MEMORANDUM

RE: Parking Departure Correction Response

Correction Response: Vehicular Parking Departure

Correction Response: Proposed Site Design

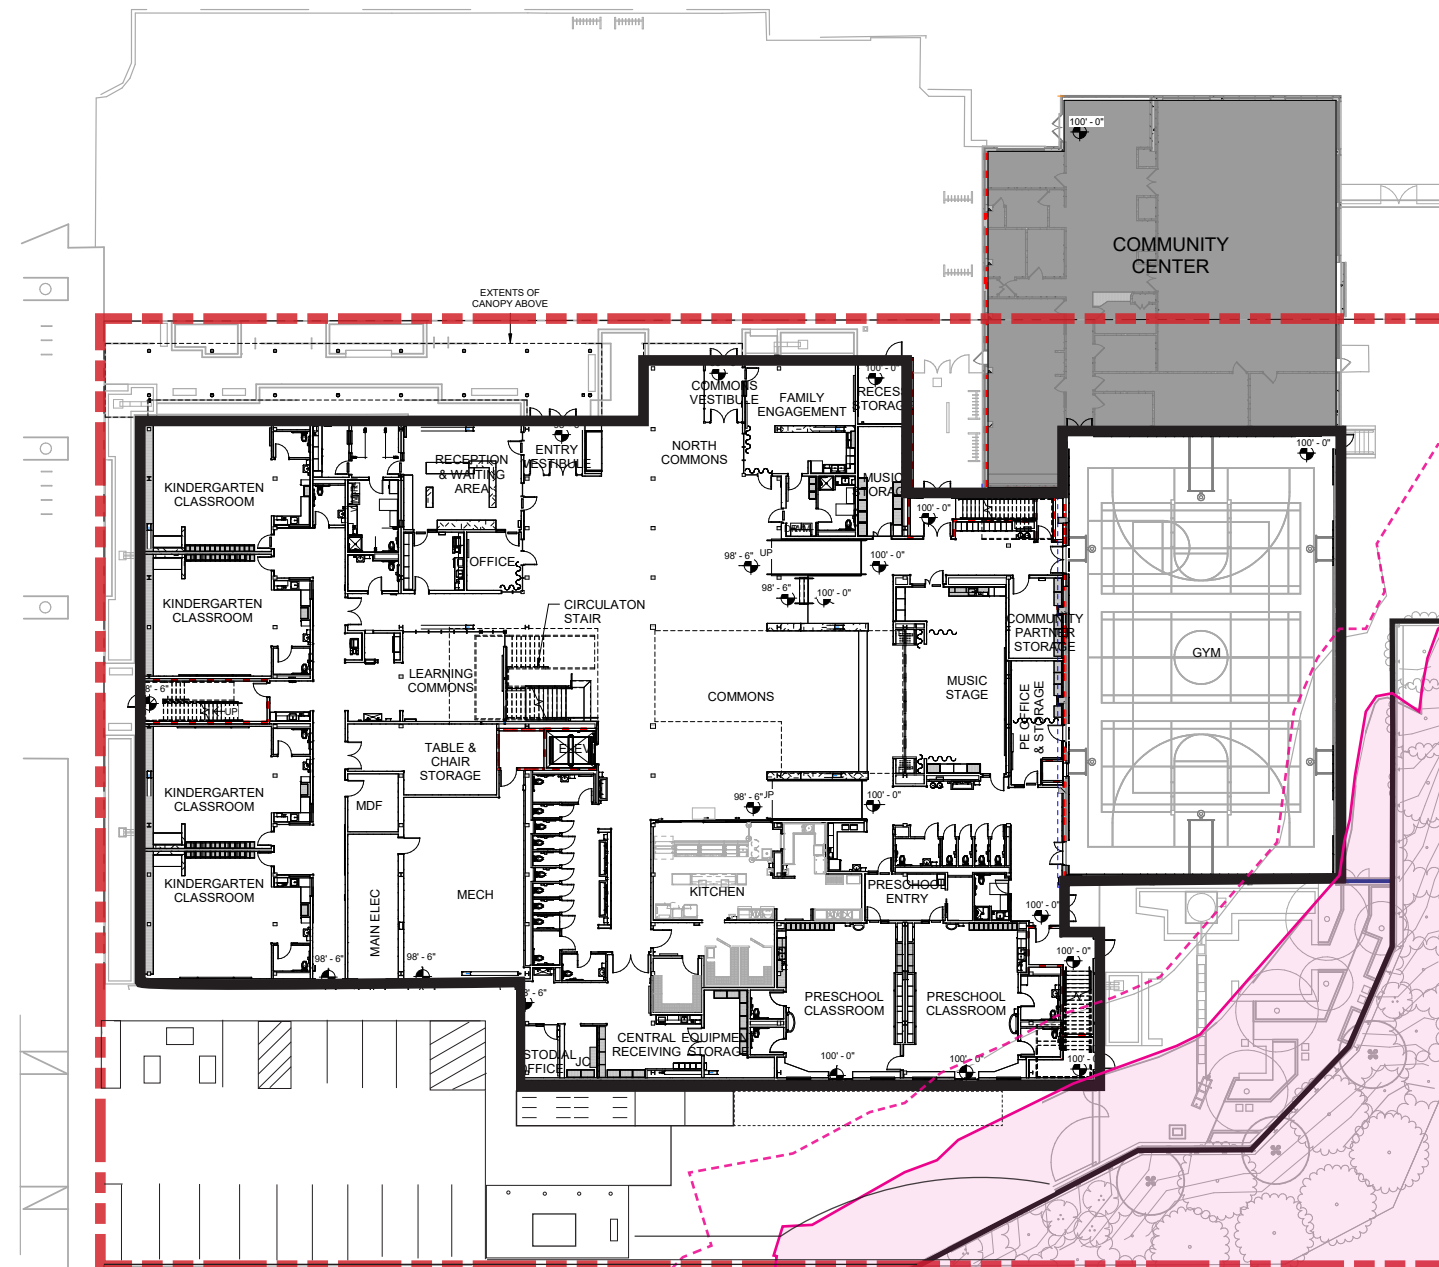
Because providing a parking garage or acquiring residential parcels proved to be infeasible, SPS reviewed possible site redesign options. Upon the Hearing Examiner's remand to SDCI, the SPS design team explored several options to provide some parking on-site. Based on the small site size and the necessary footprint of the building to accommodate the educational needs of the student population, discussed in more detail above, there were limited options for providing on-site parking outside of removing critical educational programming. As each element of the school is necessary to accomplish the educational goals of SPS, the team explored how to retain only the critical elements of the school while reconfiguring or removing features that are important and desired, but not critical to the functioning of the school. As you can see on pages 11 and 12, the prior site design had a larger loading with dedicated entry and additional storage. As shown on pages 13 and 14, the design team was able to remove the loading platform and a dedicated driveway and staging area for SPS delivery trucks and garbage pickup. The design team also relocated the proposed transformer further away from the school building, which adds a greater cost than the original design. The design team then removed some storage space from the school and reconfigured the long-term bike parking structure (while still retaining the same number of long-term bike parking stalls). Finally, the design team removed the dedicated pedestrian path at the south edge of the site. This redesign sacrificed those elements that are desired for the functioning of the school, such as better loading, storage, and separated pedestrian path and left only those architectural elements that were necessary to meet educational goals.

The result is that SPS is able to redesign the school to accommodate 15 parking stalls, including one ADA van stall. Depending on the needs of the student and staff population at the time the school reopens, it is possible that SPS can include one additional ADA stall and/or a time-limited load/unload zone. Now that an ADA stall can be included on the school site, the previously proposed on-street ADA stall across the street has been removed, which will result in retaining one additional on-street parking stall.

The building plan and educational program are not affected by the design revision.

This redesign sacrificed those elements that are desired for the functioning of the school, such as better loading, storage, and separated pedestrian path and left only those architectural elements that were necessary to meet educational goals.
